UNITED STATES PATENT AND TRADEMARK OFFICE

APPLICATION NO.	FILING DATE	FIRST NAMED INVENTOR	ATTORNEY DOCKET NO.	CONFIRMATION NO.
10/073,370	02/05/2002	Cathleen Woodall	2858	4346

**Office Action Summary**

## DETAILED ACTION

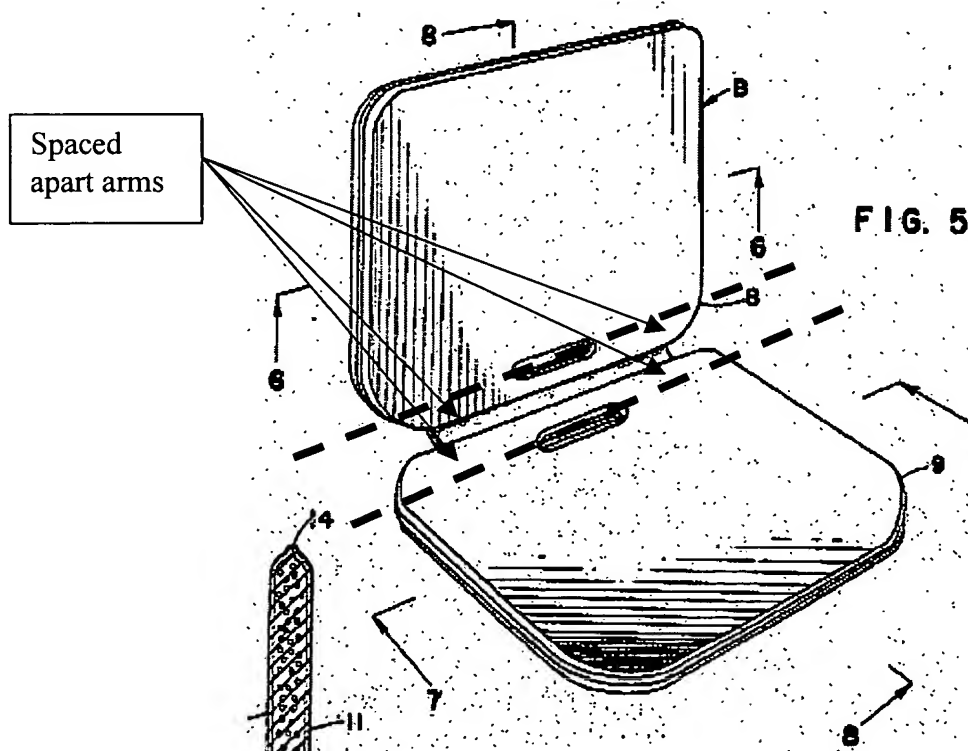
Applicant's arguments filed 3/10/03 have been fully considered but they are not persuasive.

As to the Lerman reference, applicant argues (pg.10-12) that "...there are no spaced apart arms interconnecting the handgrips 21/22 and the pads 8/9. Applicant is directed to modified Figure 5 which immediately follows this paragraph. The handle consists of the holes 17/18 and the handgrips (portions directly between the holes). The spaced apart arms are directly to the left and right of holes 17/18, and interconnect the pads 8/9 with one another. In modified Figure 5, the spaced apart arms are shown. Applicant also argues that "...the handgrips 21/22 as taught by Lerman do not constitute a single hinged handle. The examiner disagrees because the part 16 is a single hinged handle.
